# Access Compliance Report

## Public Rights-of-Way

Intersection ID: 10377	Main Street: FAISON_AV	Cross Street: N_DAVIDSON_ST	Location: N
ADA ID: EA580FD81F18	Ramp Type: Perp	Initial Pass/Fail: Fail	Overall Compliance: No
		Severity Score: 37.5

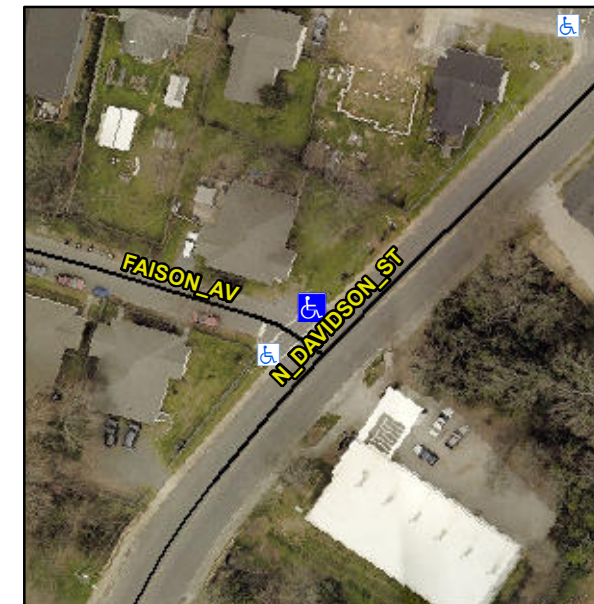
**R304.2.2, R304.5.3**

Compliance	Description	Data	Compliance	Description	Data
N/A	Ramp Length (in)	36.0	No	Ramp Slope (%)	12.6
Yes	Ramp Width (in)	48.0	No	Ramp XSlope (%)	6.5
N/A	Flare Type LT	N/A	N/A	Flare Type RT	N/A
N/A	Flare Slope LT (%)	N/A	N/A	Flare Slope RT (%)	N/A
N/A	Flare Traversable LT?	N/A	N/A	Flare Traversable RT?	N/A
N/A	Landing Length (in)	N/A	N/A	DWS Provided?	N/A
N/A	Landing Width (in)	N/A	N/A	DWS Contrast?	N/A
N/A	Landing Slope (%)	N/A	N/A	DWS Length (in)	N/A
N/A	Landing X Slope (%)	N/A	N/A	DWS Full Width?	N/A
N/A	Landing Curb? (Y/N)	N/A	N/A	DWS Offset (in)	N/A
N/A	Shared Landing?	N/A			
N/A	Gutter Ponding?	N/A	N/A	Gutter Slope (%)	N/A
N/A	Gutter Lip Ht (in)	N/A	N/A	Gutter X Slope (%)	N/A
N/A	Painted X Walk1?	Yes	N/A	Painted X Walk2?	N/A
	X Walk 1 Direction	To SW		X Walk 2 Direction	N/A
N/A	X Walk 1 Width (in)	102.0	N/A	X Walk 2 Width (in)	N/A
	X Walk 1 Slope (%)	2.8		X Walk 2 Slope (%)	N/A
	X Walk 1 X Slope (%)	1.7		X Walk 2 X Slope (%)	N/A

**Remove & Replace Entire Ramp.**
